# DESIGN DRAWINGS

*Oregon Square*

*Updated: September 14, 2015*

# COMMENTS TO ADDRESS - POST DR I

MODIFICATION #2

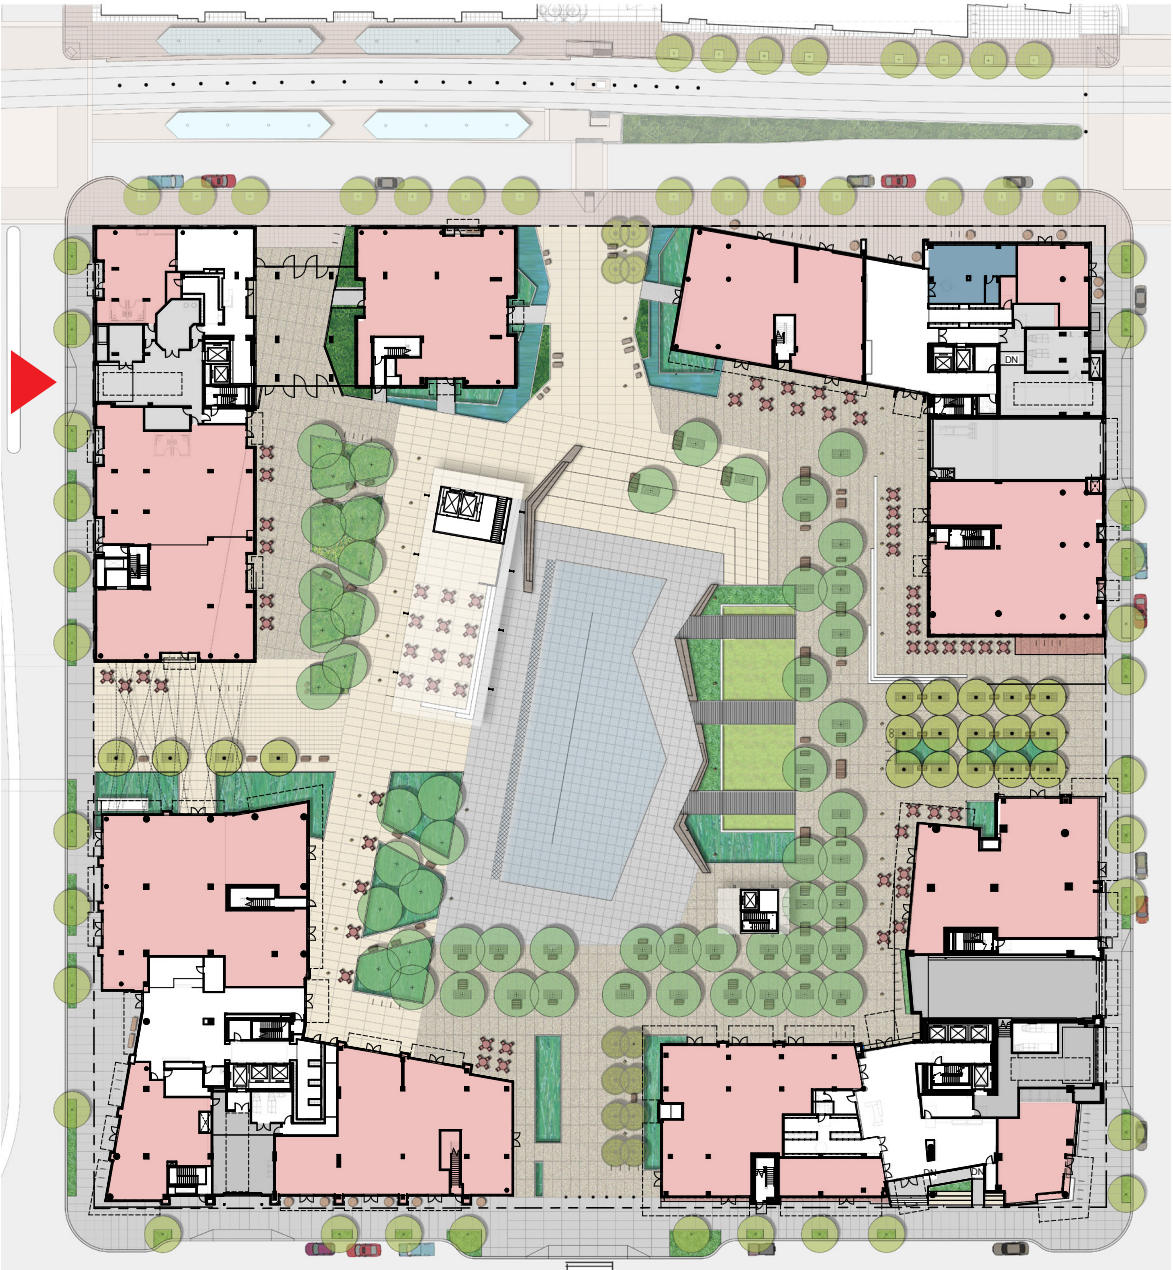
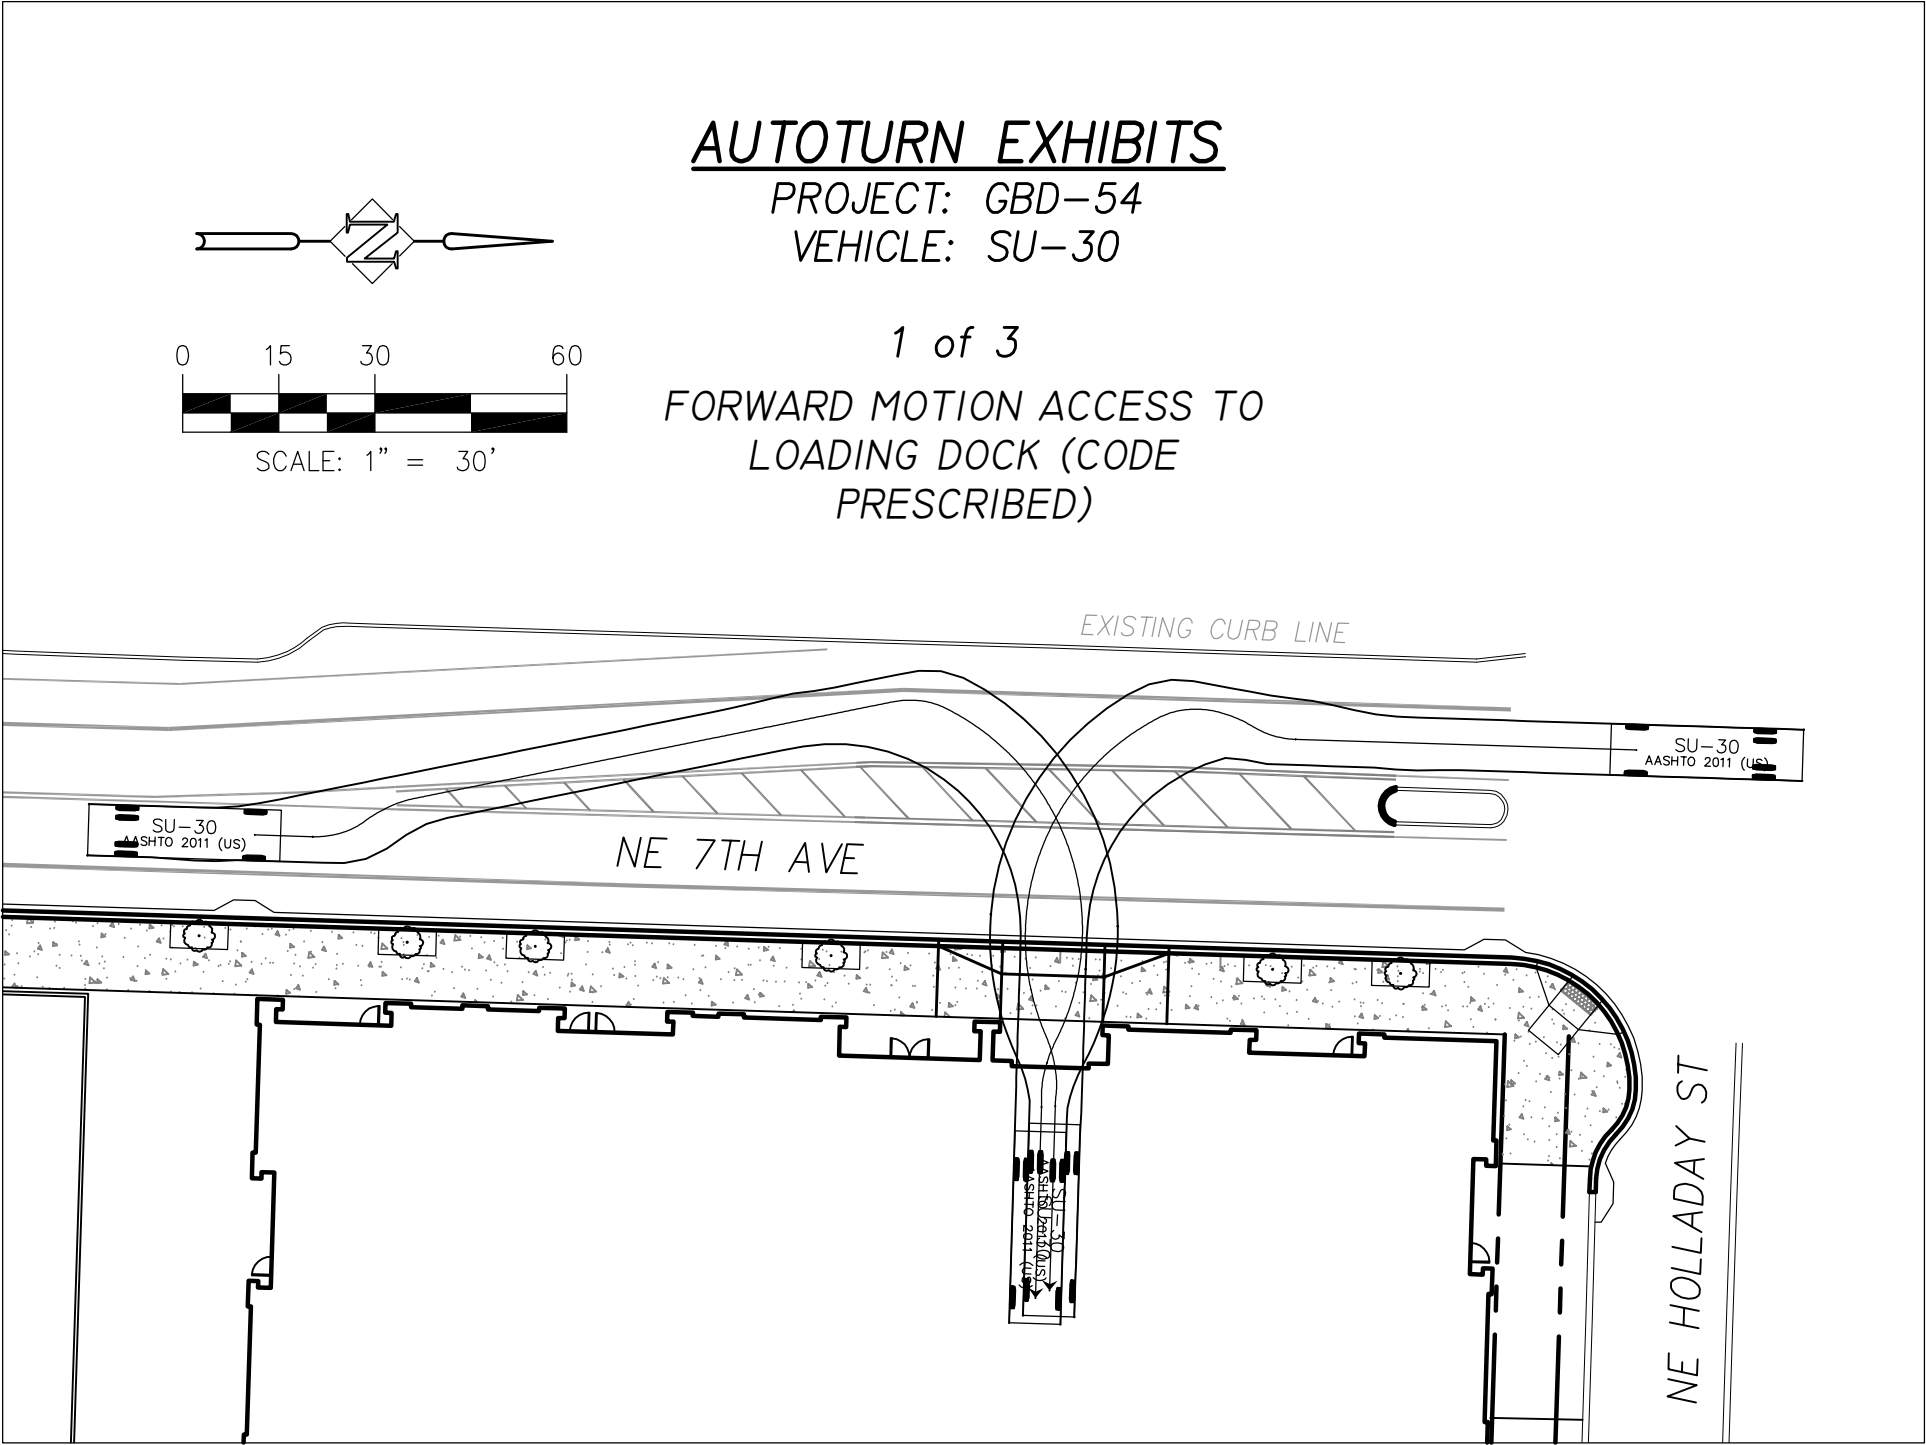
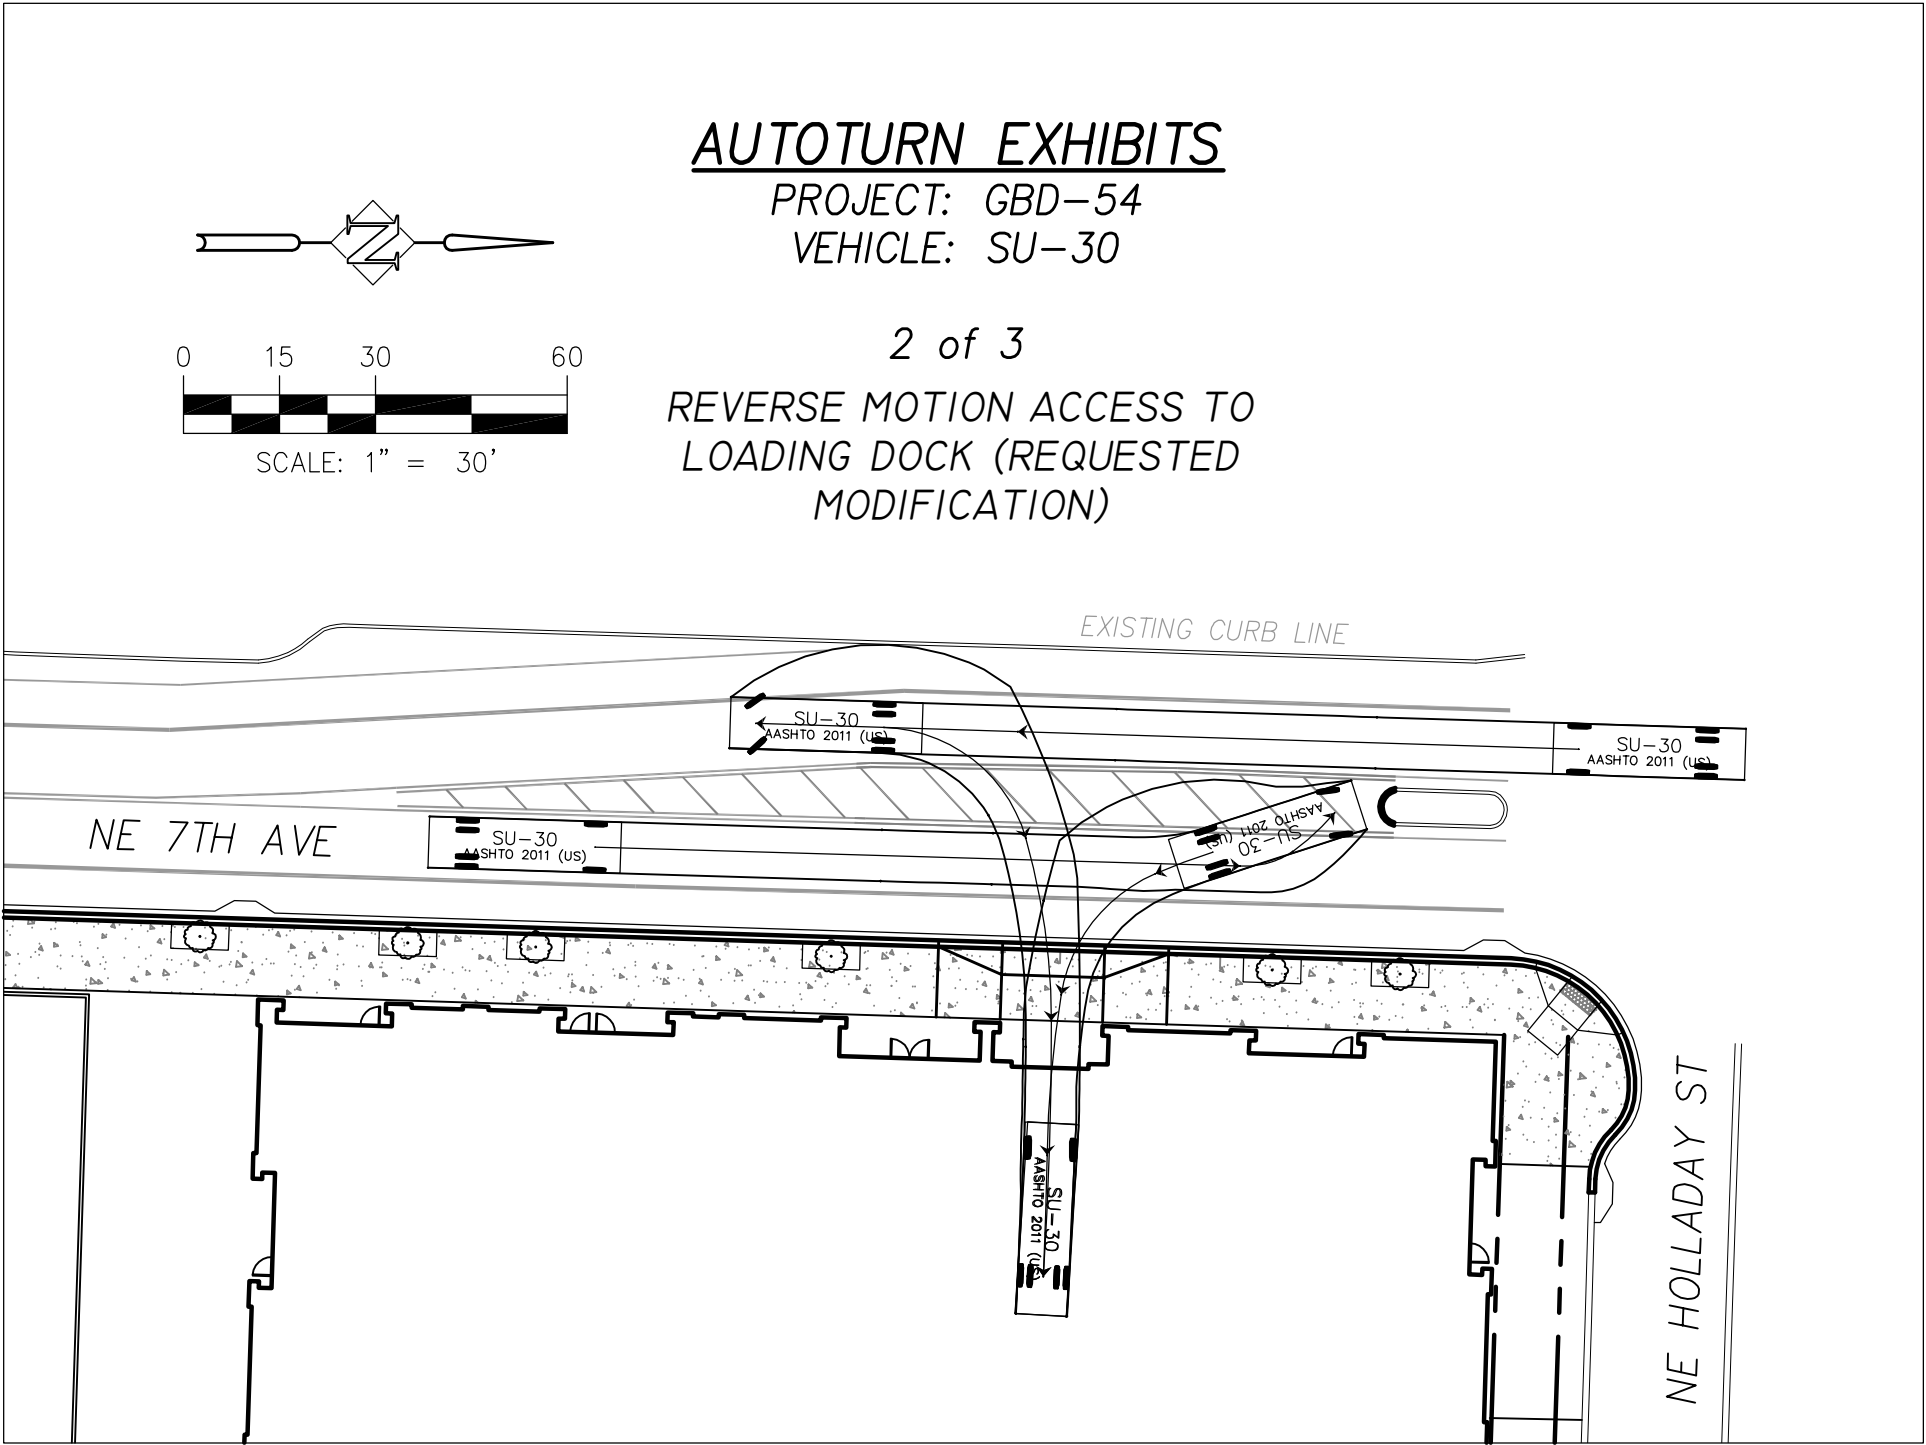
33.266.310.F.2.

General Standard: Forward motion loading: In the Central City plan district, loading facilities that abut a light rail or streetcar alignment must be designed so that vehicles enter and exit the site in a forward motion.

The Block 91 proposed loading facility meets the proscribed minimum dimensions of 10’w x 35d’ x 13’h and is accessed off of NE 7th Ave, which abuts the streetcar line running in the north-south direction. The streetcar rails occupy the southbound lane (the west side of the street), which is currently separated from the northbound lane by a concrete median. Block 91 only has two street frontages, NE Holladay and NE 7th Ave. NE Holladay is fortified by the Max station and is a dedicated “Green Street”, making it inappropriate for service functions. Block 91 fronts the central pedestrian plaza to the east and south; this plaza only sees vehicular traffic during emergencies or during special events; it is not available for daily or regular service activities. For this reason a drive-through loading bay, allowing forward motion when entering and leaving, is infeasible. The NE 7th Ave frontage is the only remaining frontage available for loading, and this can only be accomplished by reverse-motion access and forward motion exiting.

Access to the loading space is proposed to be accomplished by allowing trucks to back in to the loading space from the northbound lane. The attached loading diagrams showing the maneuvering clearances for an SU-30 truck demonstrate that the turn radius and maneuvering clearances required for forward motion access (illustration 1 of 3) are more disruptive to southbound traffic and the streetcar rail alignment than reverse motion loading, and will require removal of the existing median. Forward motion loading requires a northbound truck to swing wide into the southbound lane to access the loading dock, while reverse-motion loading (illustration 2 of 3) from the northbound lane requires a 2 point turn within the northbound lane, with no disruption to the southbound traffic or streetcar. Illustration 3 of 3 shows that forward motion exiting from the loading dock into either the northbound or southbound lanes is not disruptive to traffic flowing in the opposite direction. We request that a modification be granted to allow reverse-motion access to the loading dock on NE 7th Ave.
